IREDELL COUNTY HEALTH DEPARTMENT

IMPROVEMENT PERMIT / AUTHORIZATION TO CONSTRUCT / OPERATION PERMIT / EXISTING SYSTEM INSPECTION

PERMIT# 134315 PIN# 4730061221 DATE 4-3-06

LOCATION PERTH RD SOUTH ② HICKS CREEK ③ CORNER OF HICKS CREEK & OLD SPRUCE WAY

INITIAL SITE SKETCH

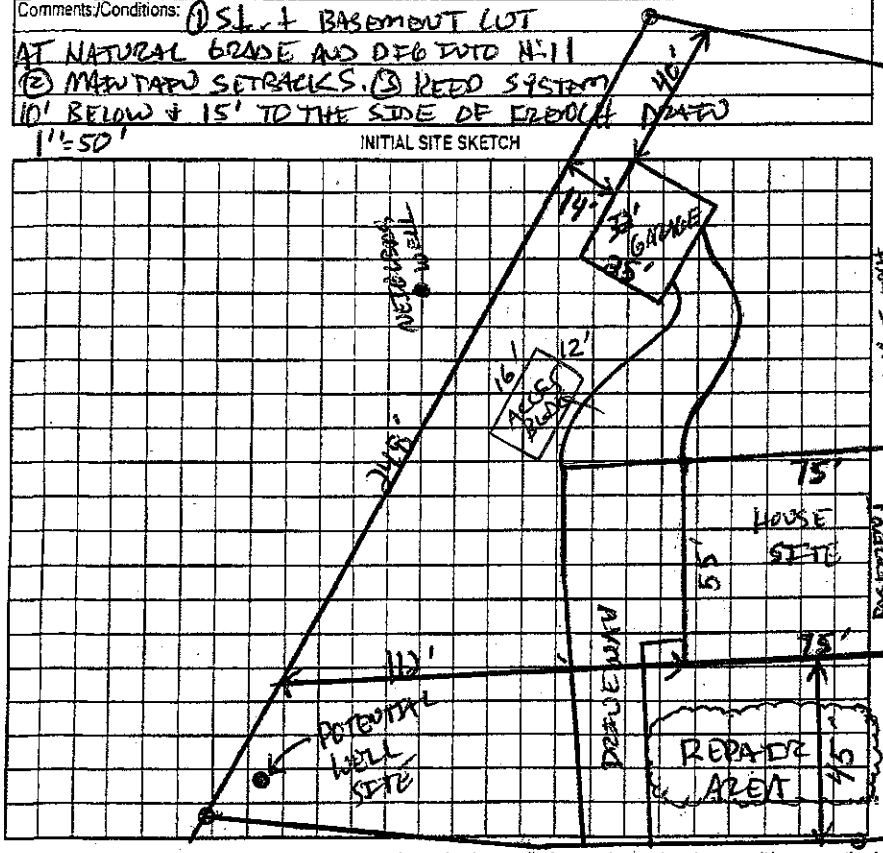
Comments/Conditions: ① SL + BASEMENT LOT AT NATURAL GRADE AND DEG INTO HILL ② MAINTAIN SETBACKS. ③ REED SYSTEM 10' BELOW & 15' TO THE SIDE OF TRENCH PATH

AS BUILT SKETCH & Instl'd FD 5' OFF HOUSE

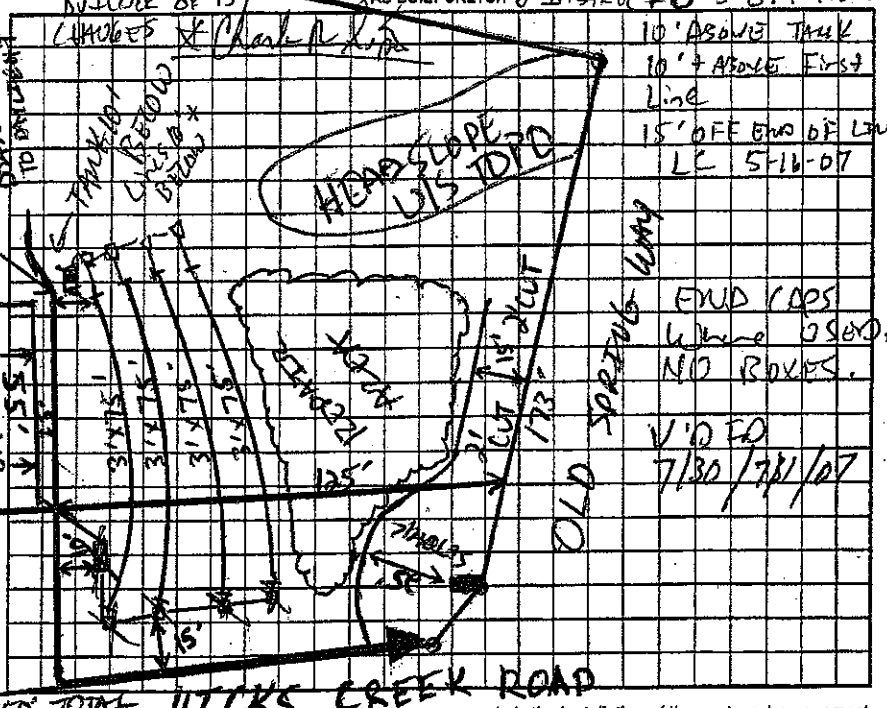
Comments/Conditions: POLYLOK F. Her ✓ LINES & TANK NEEDS FRENCH DRAIN INSTALLER WILL MARK END OF LINES
